CITY OF PORTLAND

BUILDING PERMIT

Job ID: 2011-05-1044-ALTR

has permission to install a door, balustrade & 4' bridge on garage roof.

Descriptor/Area	Area
A:.....	1470 sqft
B:EP	134 sqft
C:.....	352 sqft
D:.....	32 sqft
E:1Fr/DP	22 sqft
F:DP	44 sqft
G:.....	30 sqft

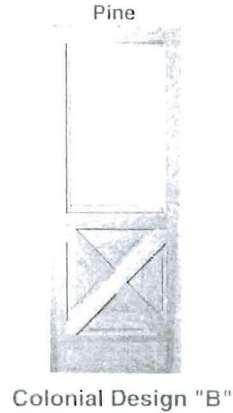
See new
dimensions
received
5/17/11 to
meet lot coverage.

- footprint is measured percola - 35.2ϕ
 from columns - ~~because~~ $5'11" \times 5'11" = 35 \phi$ (ok)
 2' overhang etc like a roof. ~~$9 \times 19 = 126 \phi$~~
 setbacks - columns 7' from front.
 5' from overhang (ok)
 ok $\leq 144 \phi$
 revised columns 9' from property
 ϕ is 35 - so (ok) needs to be min. of 5'!

From: Oldham Ted <toldham@mac.com>
To: <amachado@portlandmaine.gov>
CC: Andrews Deb <dga@portlandmaine.gov>
Date: 5/16/2011 5:38 PM
Subject: 25 vaughan st pergola revised
Attachments: 25 rev pergola1 5.16.11.pdf

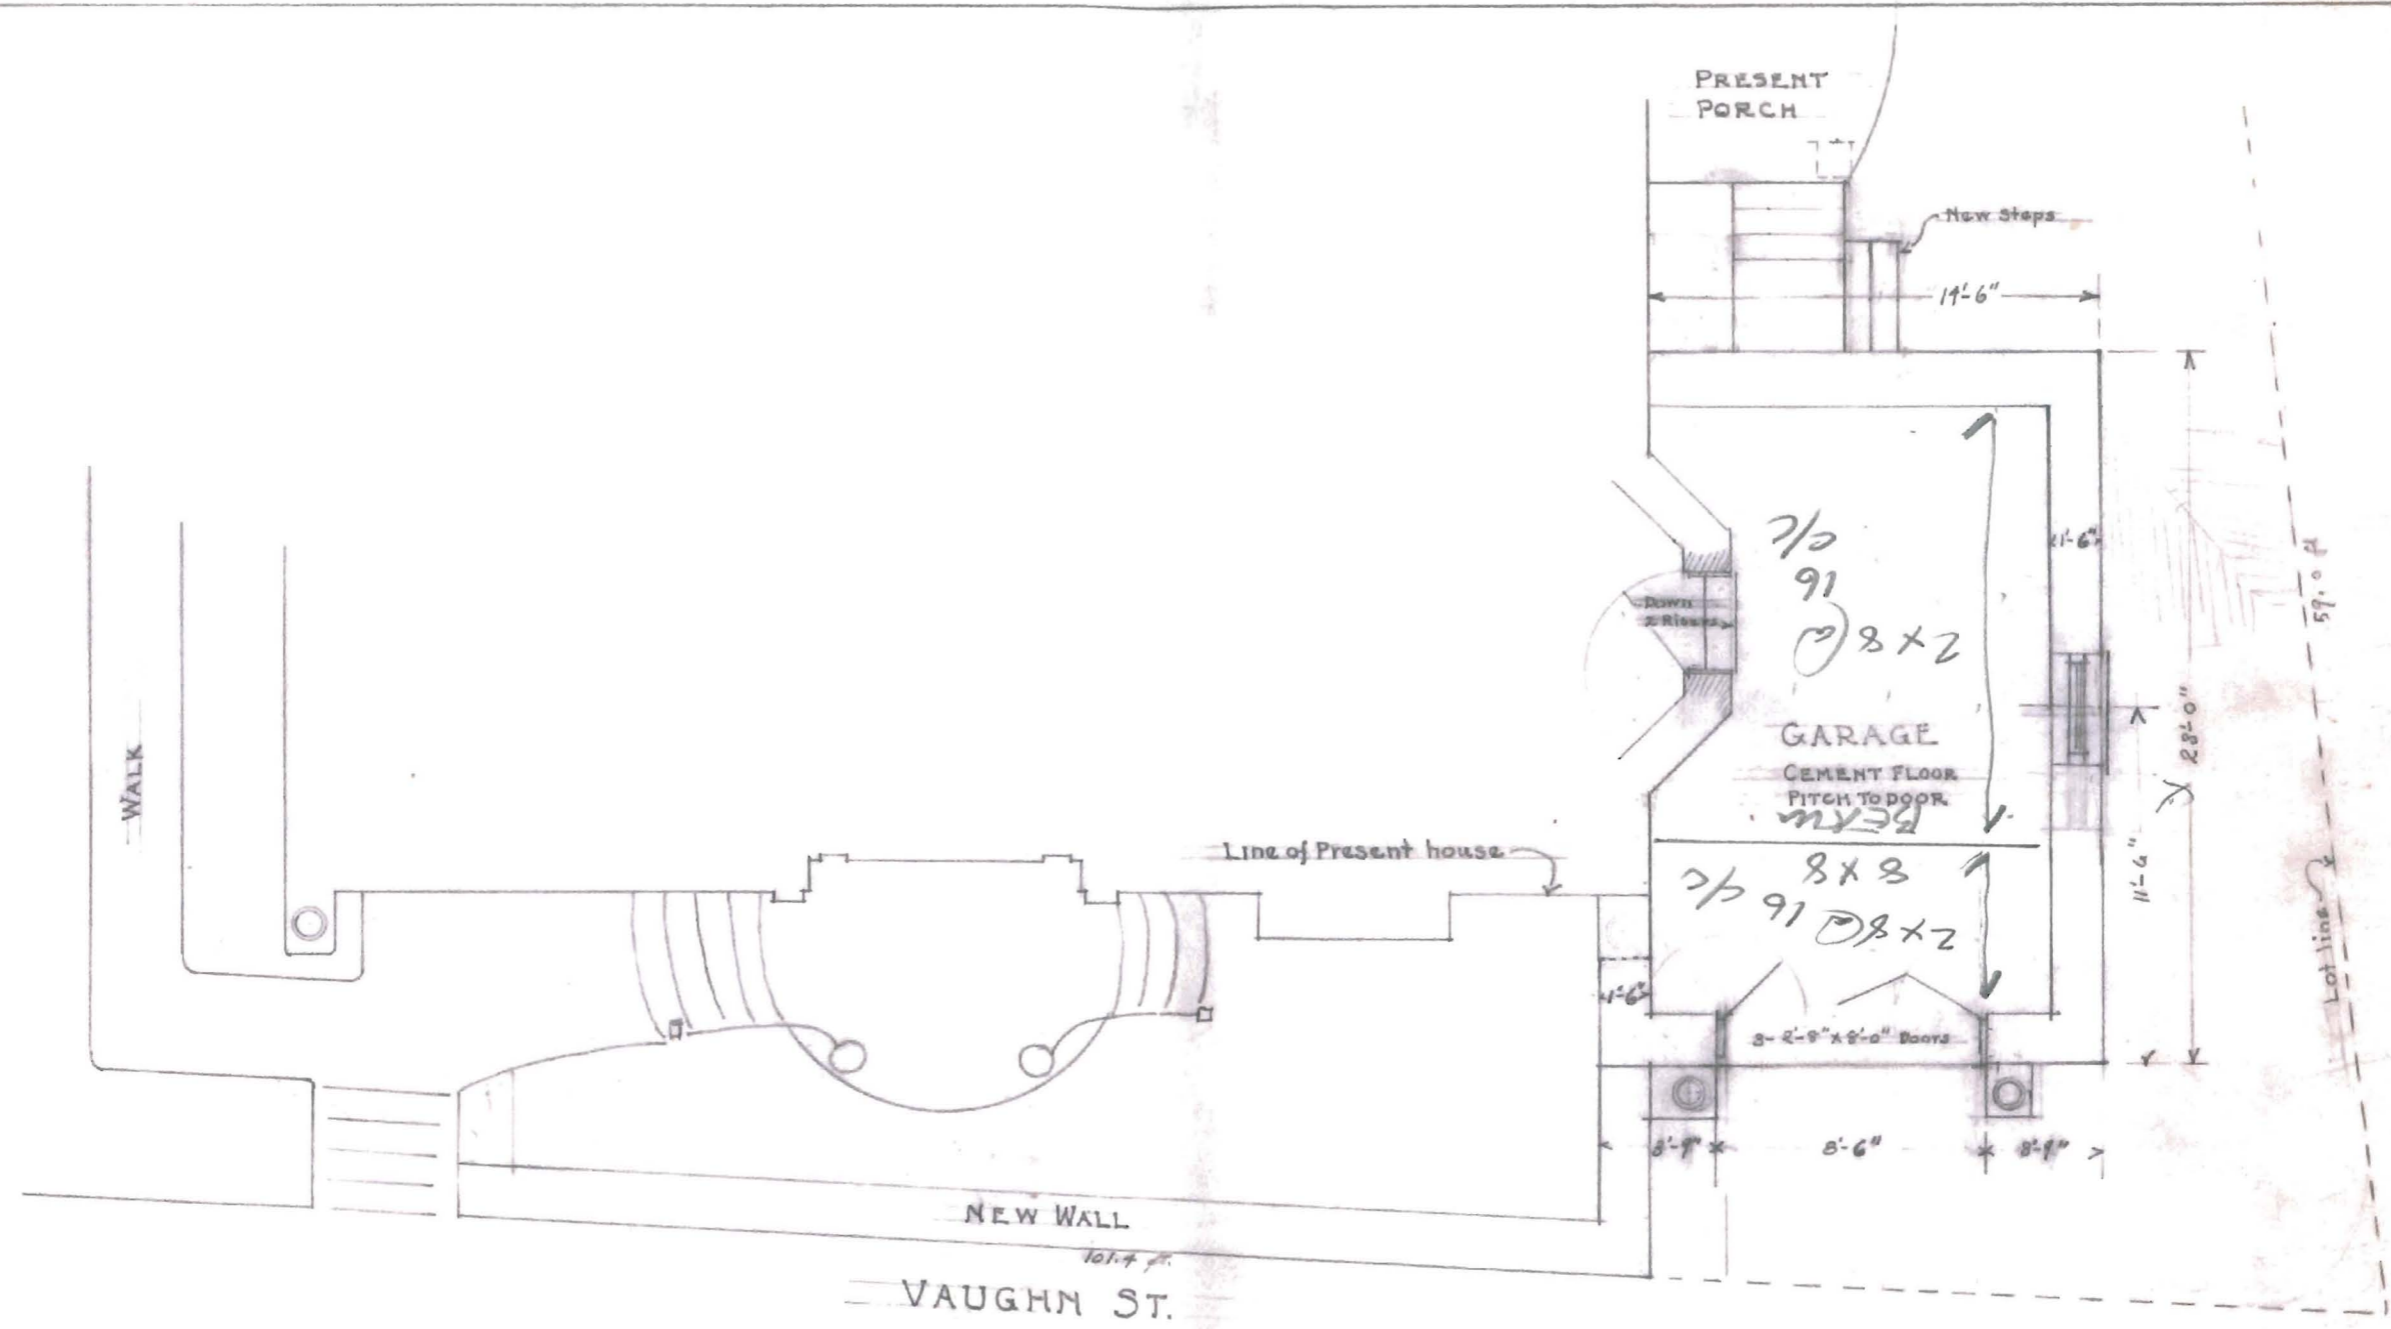
Per our discussion Monday afternoon, I attach a drawing of the revised pergola. The columns are located 5'-11" center to center both directions which is ~35 square feet of area. The open lattice work will overhang 2' on either side. I hope this now meets the coverage allowance.

Proposed Pergola:

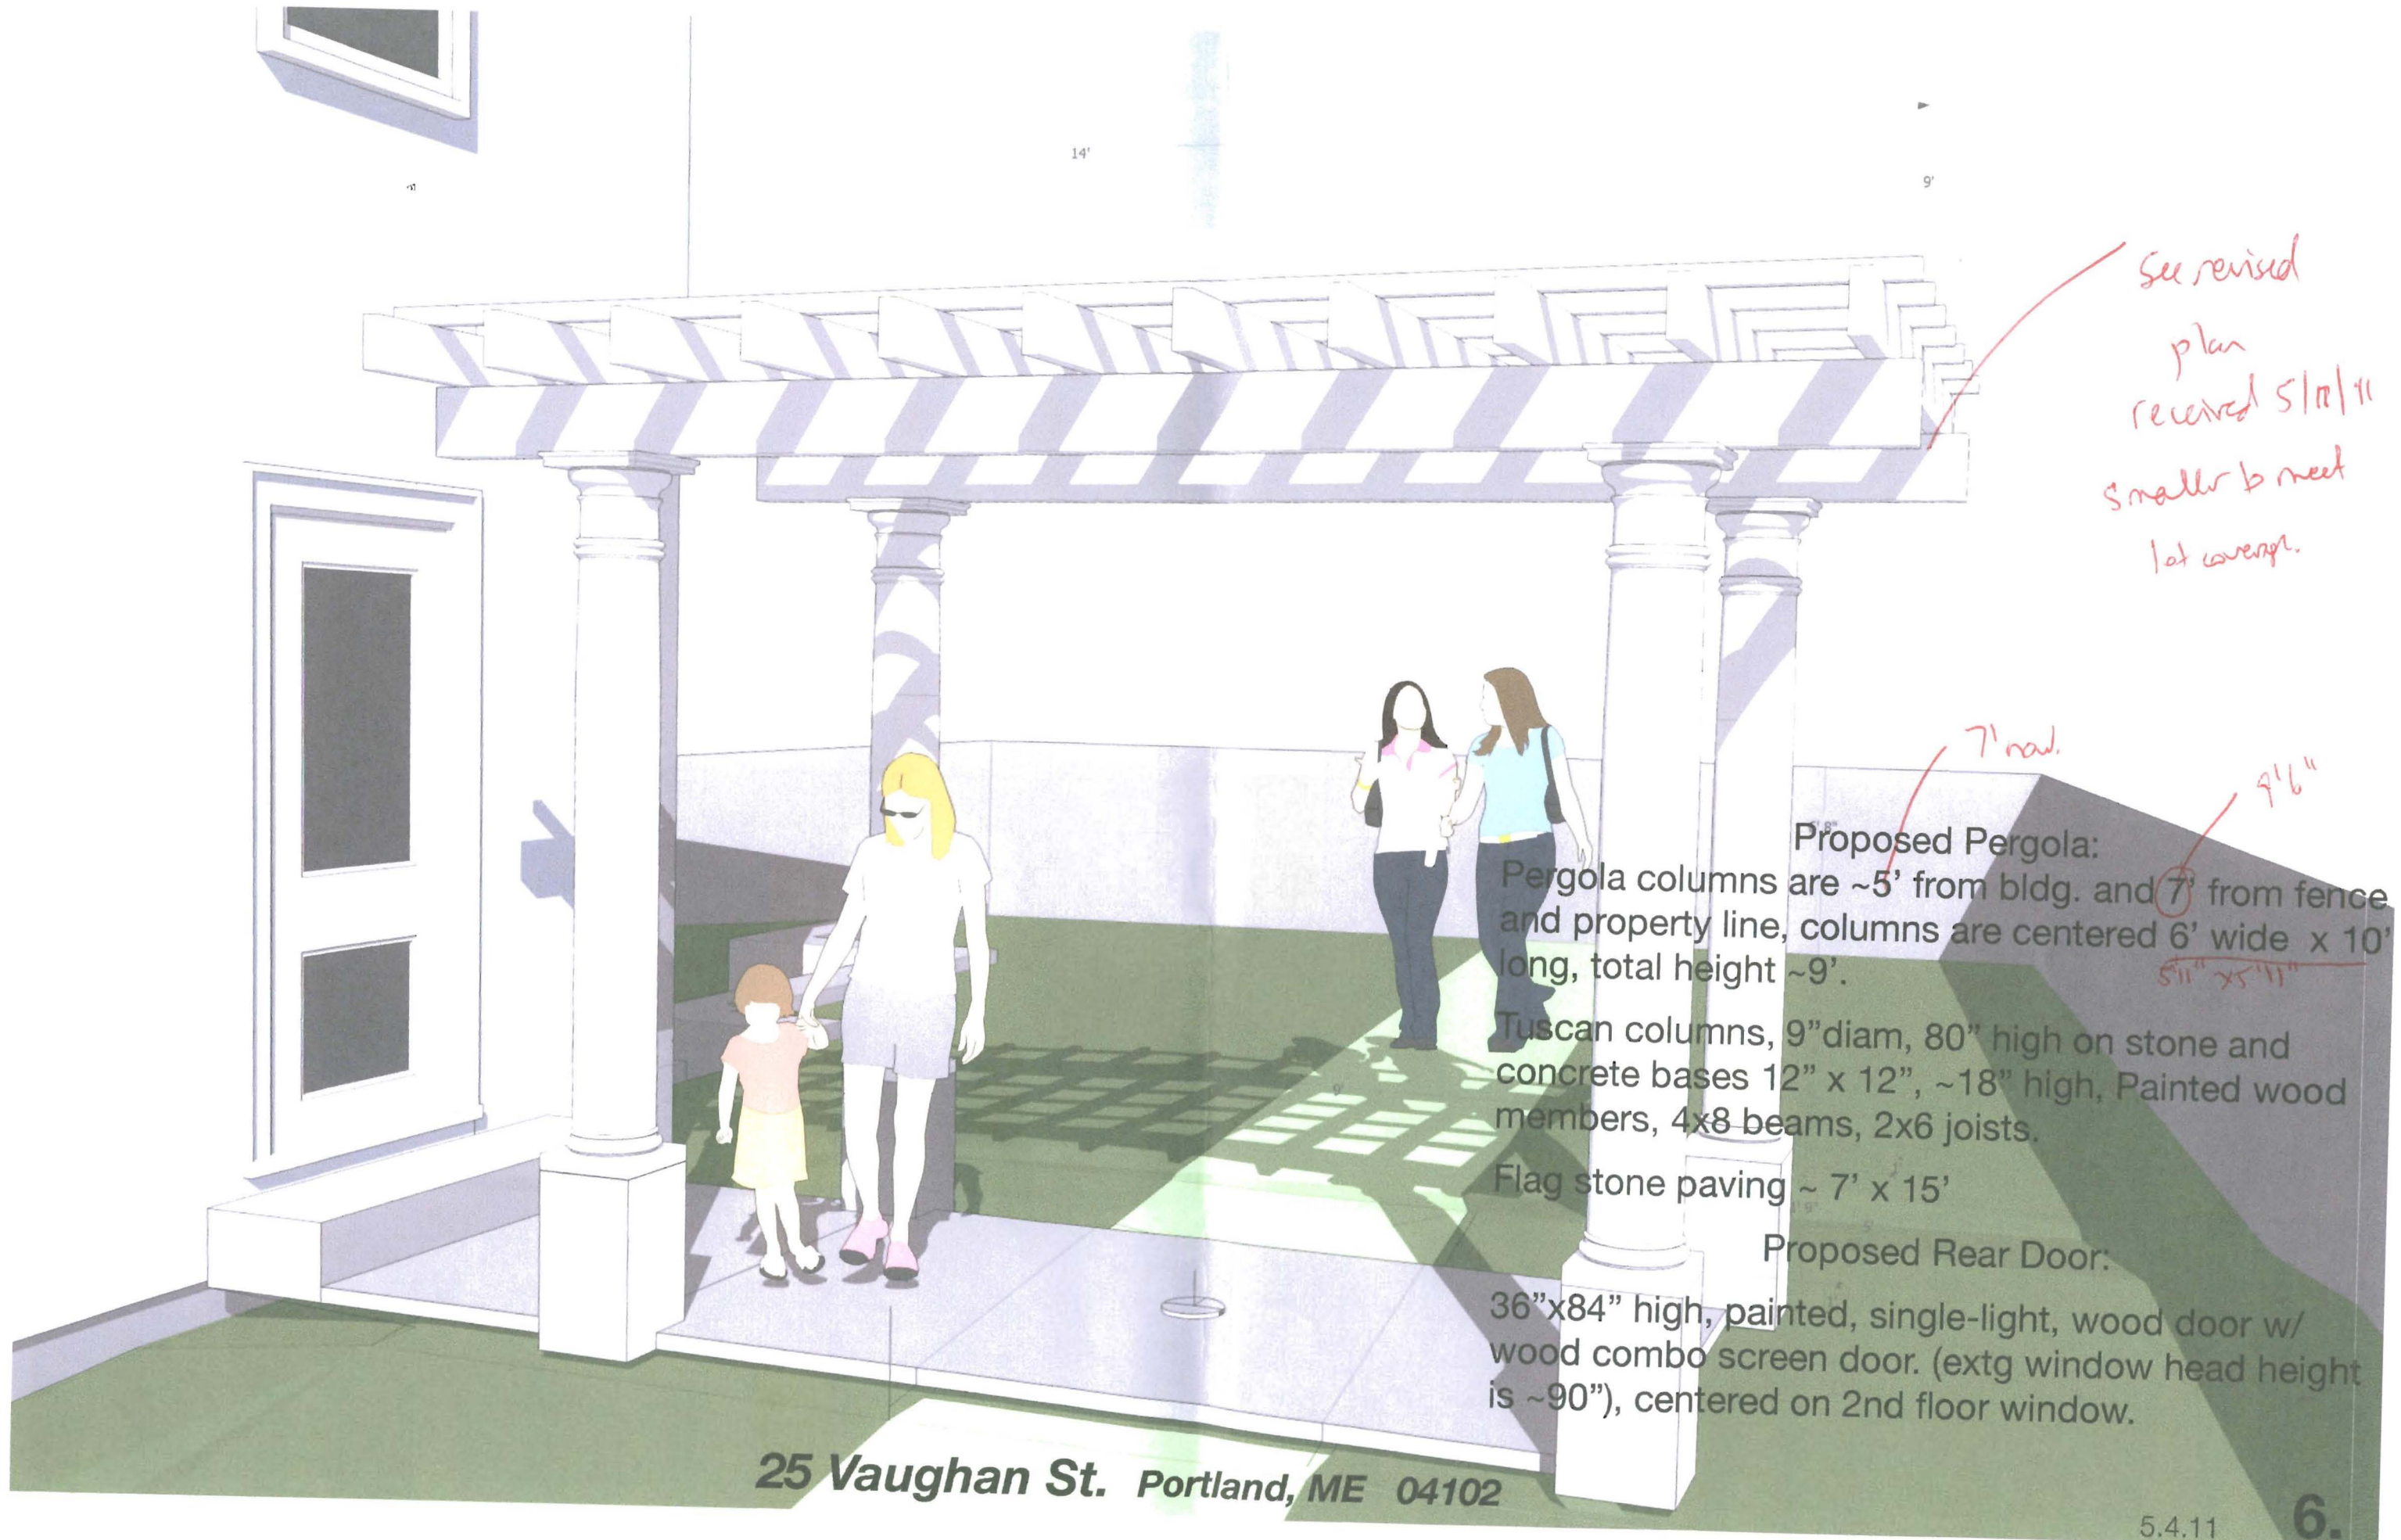
See revised plan received 5/17/11 smaller to meet lot coverage.
